Bridge Tech Committee – Design & Construction Subcommittee Meeting

2017-03-21

Bridge Technical Committee Structures Design & Construction Subcommittee

SUBJECT: DECKING OF PRESTRESSED GIRDER BRIDGES

- ▶ Open Action Items Following Last Meeting
 - Concrete Overlays at Expansion Joints

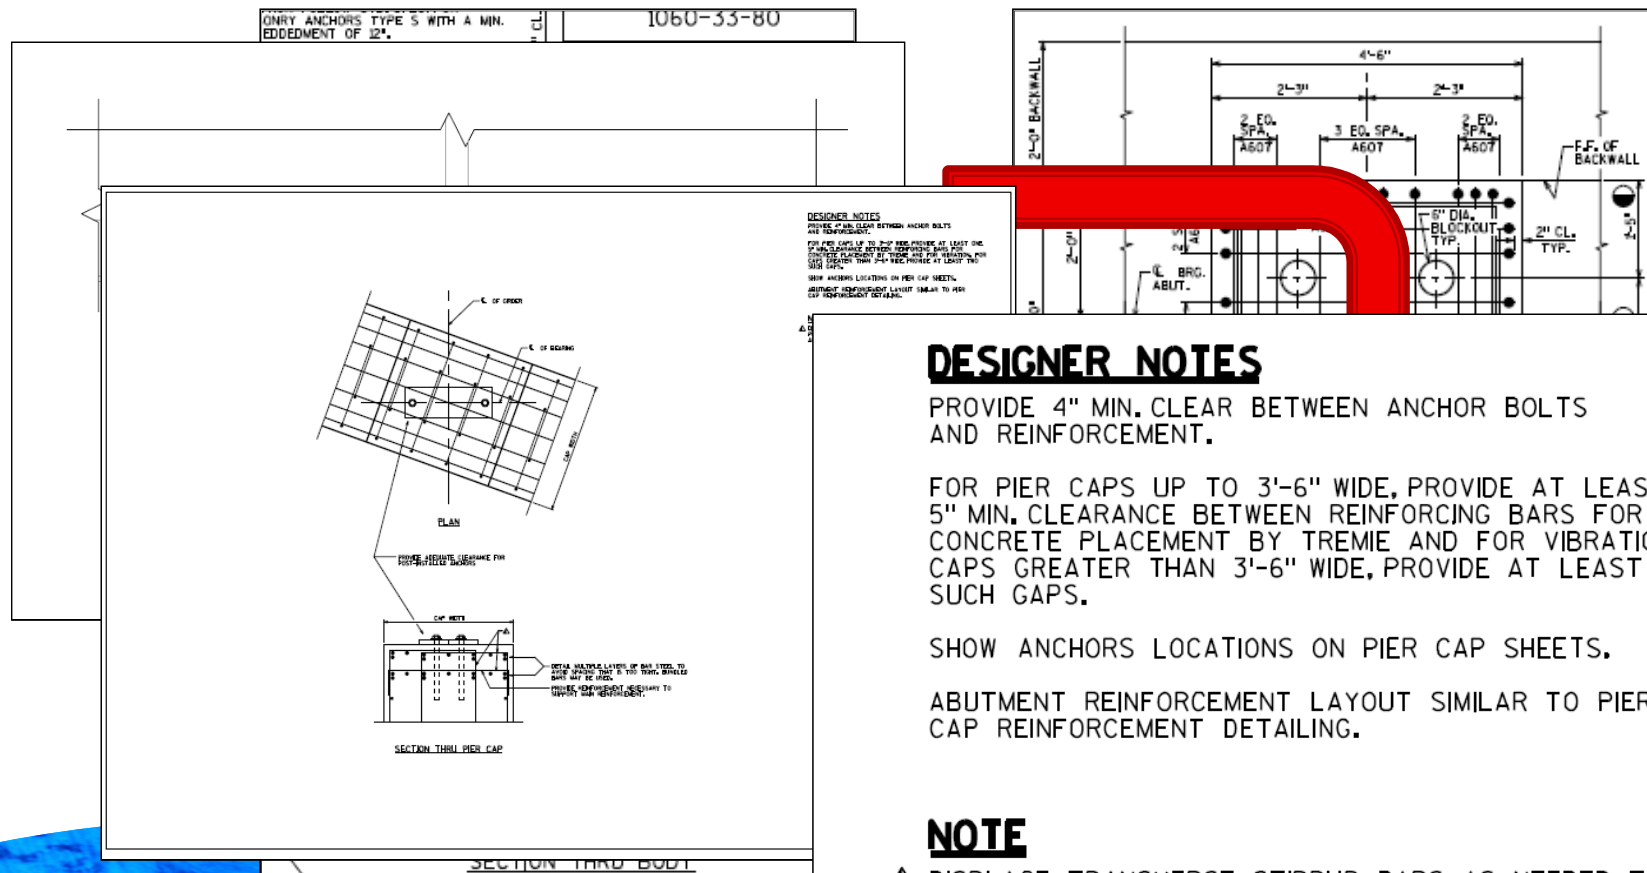
Standard plan detailing calls for a full-depth paving block and end diaphragm pour to be done monolithically with the concrete overlay. Historically this detail has not been constructed this way – industry has held the paving block and end diaphragm pours down to the bottom of the overlay elevation and comes through with paving equipment to pour the overlay over the joint. BOS’s concern is for the long-term maintenance of the paving block to resist spalling. Industry’s concern is with getting a satisfactory ride quality on both sides of the joint. *Industry will follow up to determine exactly why the current detail can’t be followed, particularly why the paving blocks at both ends can’t be poured full-depth. BOS will review the detail and potentially allow for the contractor to pour the end diaphragm prior to pouring the concrete overlay on the deck side of the joint (i.e., optional construction joint below the overlay on the deck side). Any updates will come in the form of Standard detail updates in the next update to the Bridge Manual.*

2016-03-24: Dan Kowalski followed up with a phone call to BOS based on his research into how Lunda constructs this detail. Dan indicated that Lunda has historically poured the paving block to the bottom of the extrusion and finishes the paving block pour with the overlay. Dan stated that there are issues with moving batch trucks over the joint on wider pours and also that matching in the overlay pour with a previously completed paving block pour would cause the ride to be compromised. Another item of note is that field engineers/personnel have routinely told the contractors to hold the pours down to improve the ride at the joint, conflicting with the plan details.

2017-01: BOS updated the Standard Detail 40.04 to show an optional construction joint below the reinforcing steel in the paving block, and the end diaphragm poured below to allow the overlay to extend to the joint extrusion. This detailing practice should begin to show up in plans in the near future. If the old detailing is shown in a plan set, the contractor should work with the project PM and BOS to allow the now current detailing option.

- ▶ Open Action Items Following Last Meeting
 - Substructure Reinforcing Steel Conflicts

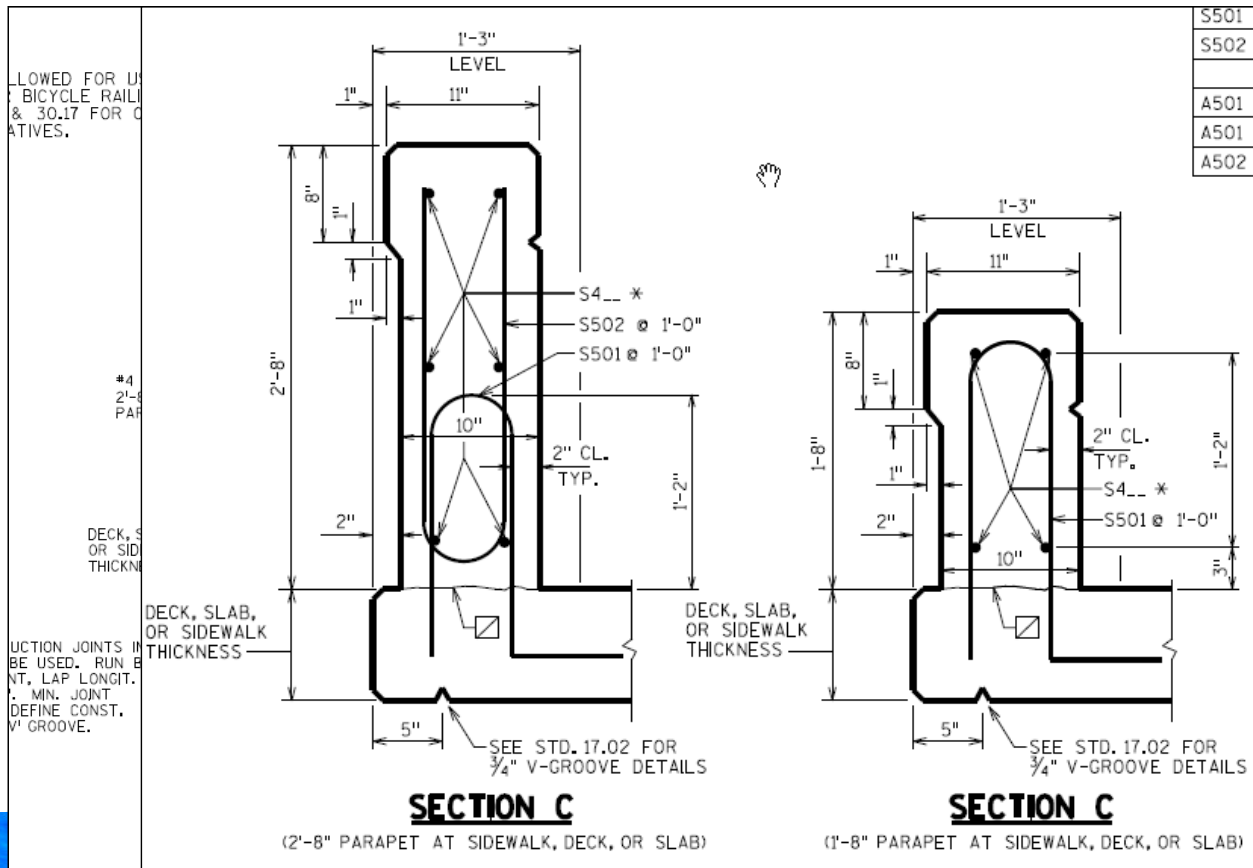
Contractors routinely encounter reinforcing steel in substructures when drilling for bearing anchor bolts. Designers should account for potential conflicts by bundling bar steel, utilizing or allowing for embedded blackout cans (in certain situations only as they are difficult to use in the field for industry), and providing allowable clearance details in the plans for clarification. WTBA recommended that a minimum of 4" clear for anchor bolts be used as guidance. WTBA also recommended that as much clear space as possible (5" to 6") be provided to allow for vibrating equipment, flow of concrete, etc. Zenith Tech stated that they utilized coped flanges on prestressed girders to allow for easier flow of concrete at diaphragm locations. *BOS will provide guidance to in-house and consultant designers with clearance recommendations and potential coped girder flange standard detailing in future updates to the Bridge Manual, and will mention both items at the June 2016 Structural Engineers Symposium.*

2016-07-19: BOS created a new Standard 13.08 to highlight the need for designers to address this in design as best as possible. Additionally, this topic was addressed at the June 2016 SE Symposium in the construction lessons learned portion of the agenda. Contractors should continue to be proactive in their field reviews prior to setting reinforcing steel and placing concrete in order to avoid potential conflicts.

- ▶ Open Action Items Following Last Meeting
 - Cast-In-Place Vertical Parapet Reinforcing Steel

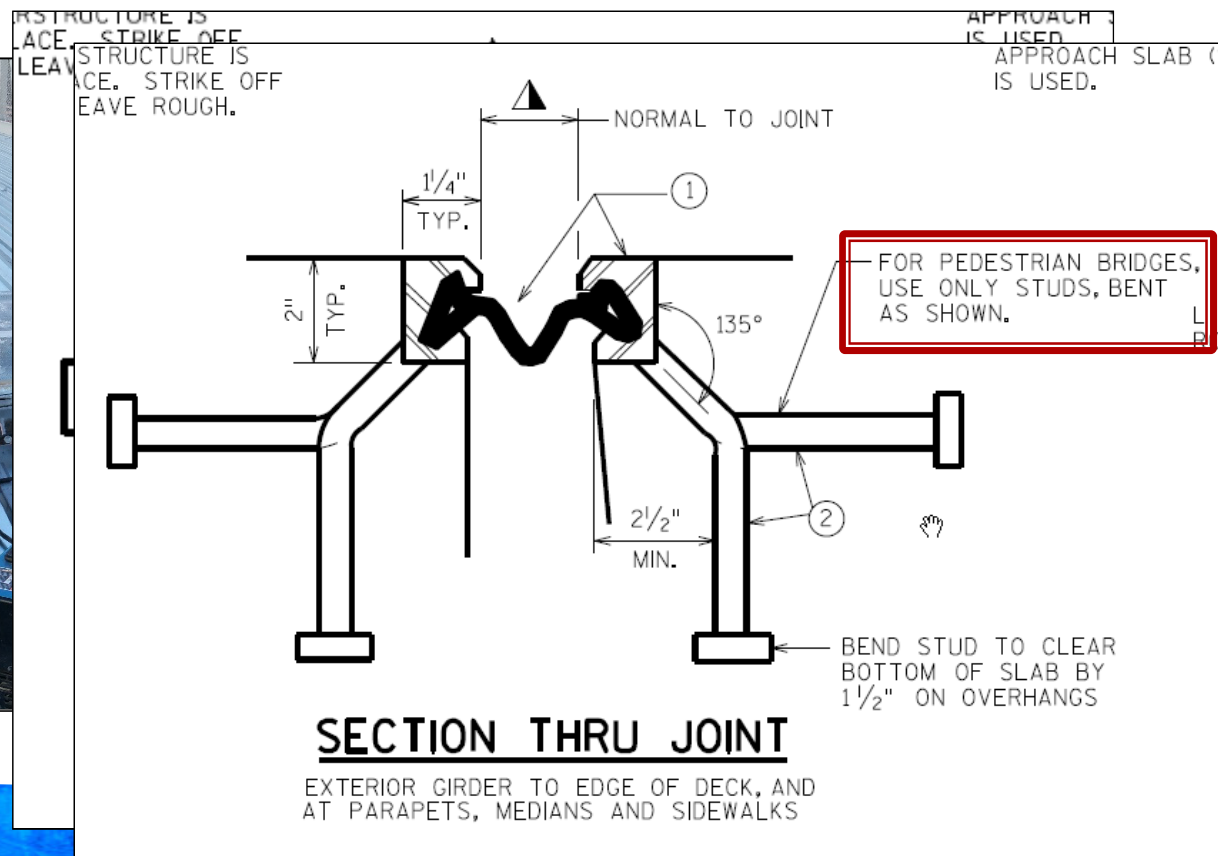
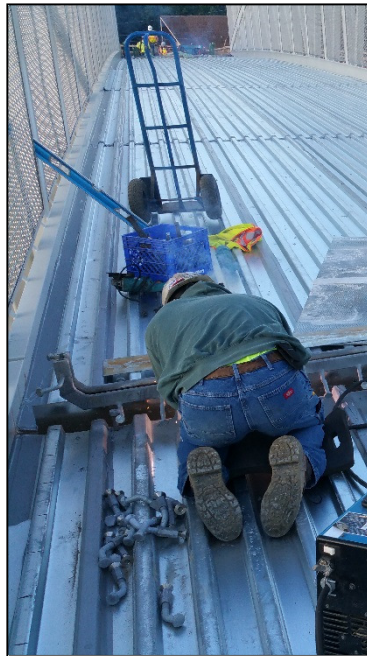
Industry has expressed concerns that vertical face parapet bar steel extending out of deck causes issues with paving equipment during the deck pour. This is also an issue at wing locations. *BOS is currently working on updated Standard parapet reinforcing steel detailing and will provide guidance through the next update to the Bridge Manual.*

2016-07-19: BOS has updated a number of Standard Details to address this issue. The new Standards show two separate vertical reinforcing bars similar to the sloped face parapet details. These details will not be published at this time because of impending MASH crash testing criteria verification, but will allow a field change to be made upon request.

2017-03: BOS is continuing to work on refining the detail to avoid any conflicts and also is still assessing the MASH

crash testing criteria. BOS plans on updating the Standard with the July 2017 Standards updates. Contractors may request to use modified reinforcing steel details on a project via RFI for projects that do not show the two-bar system.

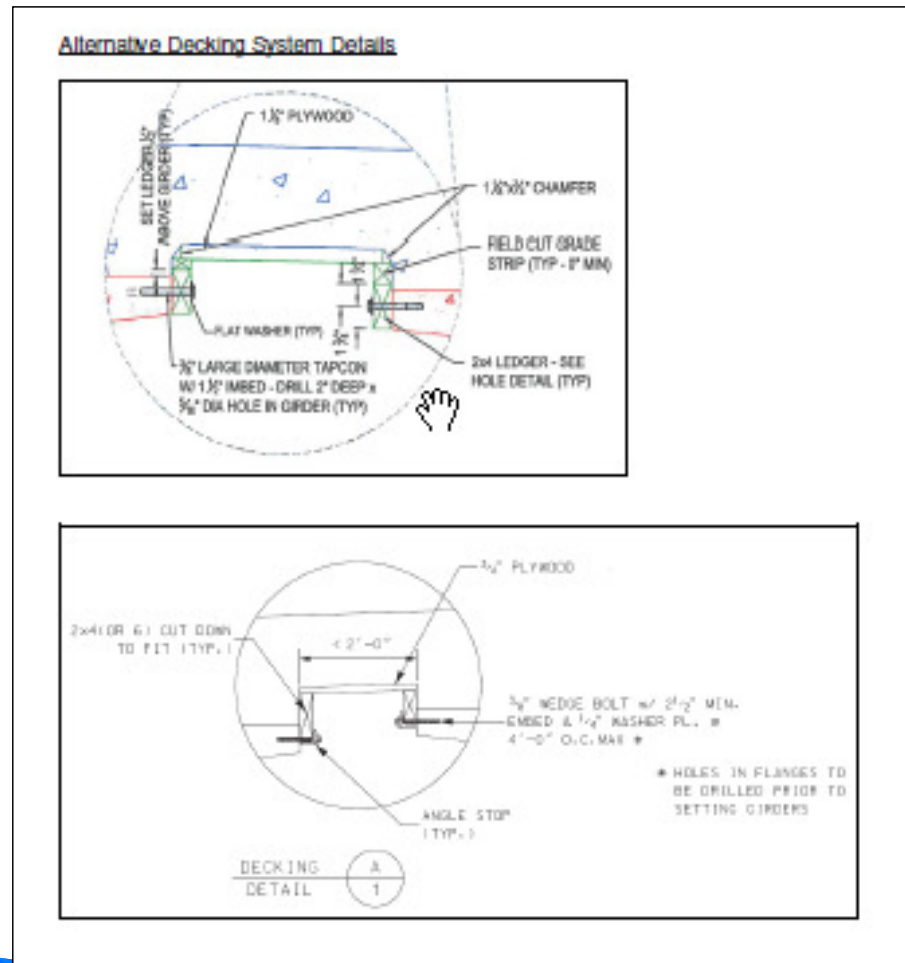
BOS has concerns with the impact that the alternative decking systems pose to the thin top flanges of prestressed concrete girders. Some of the main concerns are as follows:

- Potential increased susceptibility to damage of prestressed girder flanges in the future when removal of deck occurs for redecking projects
- Potential spalling of top flanges, which in turn causes safety risks to the traveling public below
- Potential structural capacity issues if full top flange of girder section is not present due to damage

- ▶ Parapet Reinforcement Plan Location Preference
 - When bars protrude from one element into another, where should those bars be placed in a plan set?

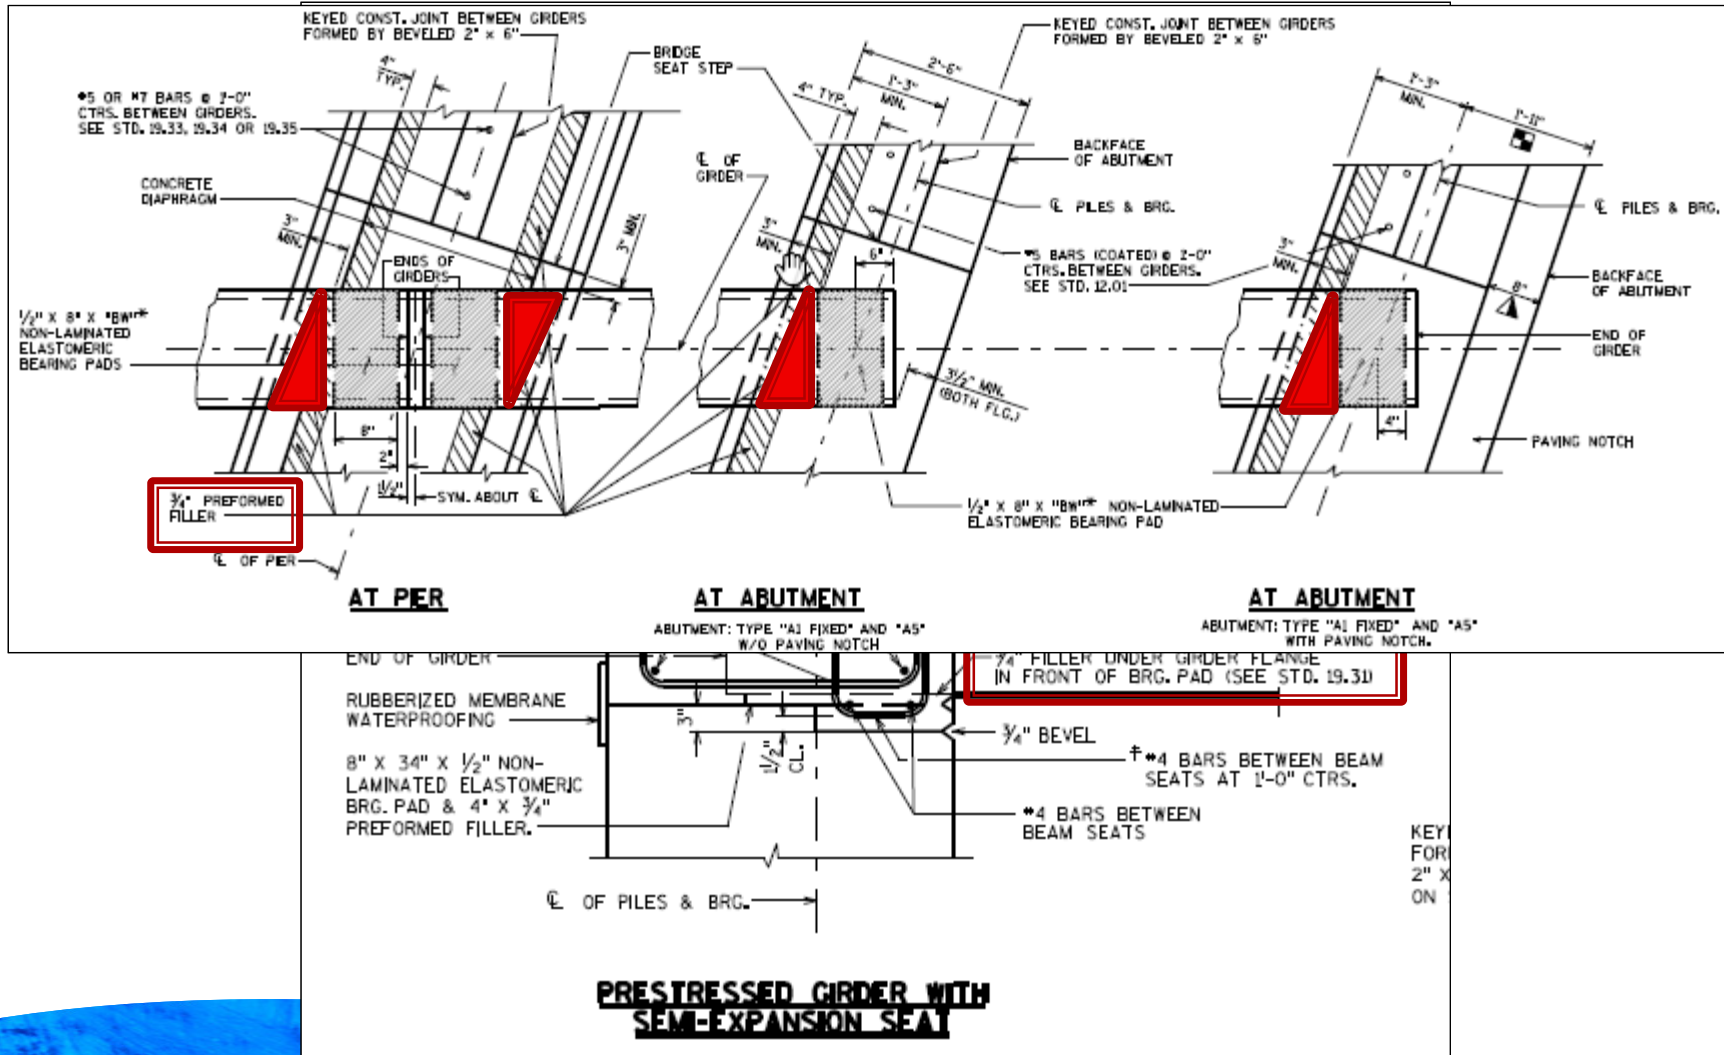
BOS inquired with industry about their preference on the location of reinforcing steel locations in the plans when bars protrude from one element into another. For example, does industry have a preference on what sheet the vertical bars protruding from the structural approach slab to the parapet above are shown (i.e., the structural approach slab sheet, the parapet sheet, other)? Also should the same bar mark be used for bars that have the

same length and shape but are located in multiple locations?

2017-03-21: Industry indicated that rebar gets shipped to the project site at the time that it is needed. Preference is to show rebar where it will get tied. As long as it is not shown on more than one bar list, it isn't a problem that it is shown in multiple locations on different plan sheets. If one bar mark is used for all bars of the same length and shape, bar tables should indicate how many at each location.
